# INDEX INSTRUMENT SERVICE ADVISORY

COMMANDER® PPC(TM) (50)

DATE:
11-AUG-1999

Figure 3. Wash Actuator Assembly

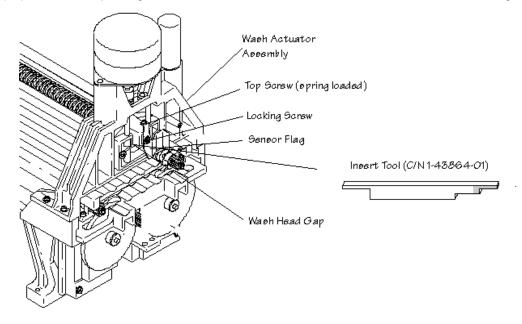
19. With the Wash Head in the down position, the desired condition is for the setting-end of the tool to enter the gap with a slight resistance. The final condition requires the first step (0.015-inch) on the checking-end of the

- tool must enter the gap but the second step (0.035-inch) must not enter the gap.
- 20. If adjustments must be made, use the <ENTER> key to move the Wash Head between Home and Down position to perform the adjustments and checks.
- 21. If the setting-end of the tool enters the gap with excessive play, make adjustments by performing the following procedure. With the Wash Head in the Home position, use the Phillips Head screw driver to loosen the locking screw on the side of the Sensor Flag. Turn the spring loaded adjusting screw on the top of the flag counterclockwise to reduce the gap.

NOTE: This is a very sensitive adjustment. The total adjustment range is only 0.020 inch. One full turn of the screw will move the flag approximately 0.032 inch. Adjust the screw in small amounts, each about 1/8 or 1/4 turn.

PPC CPU Board (Clock Chip Location - U1)

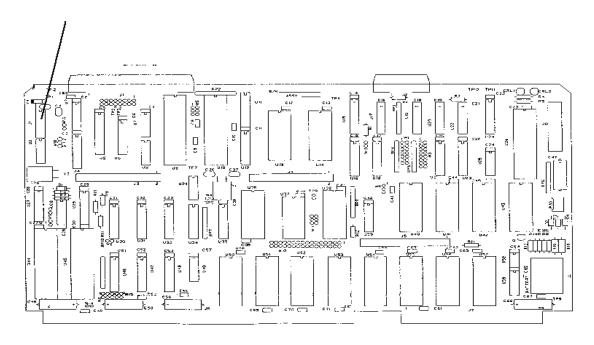
The manufacturer of the PPC clock chip has recalled the device for intermittent failures. Under certain voltage and temperature conditions, the device will fail to maintain current time. Observed failures are that

Examine clock chip on CPU board in FSR PPC kit. The clock chip is located (**U1**) on the CPU board. All CPUs that must be replaced have clock chips with serial number MM58274**B**N.
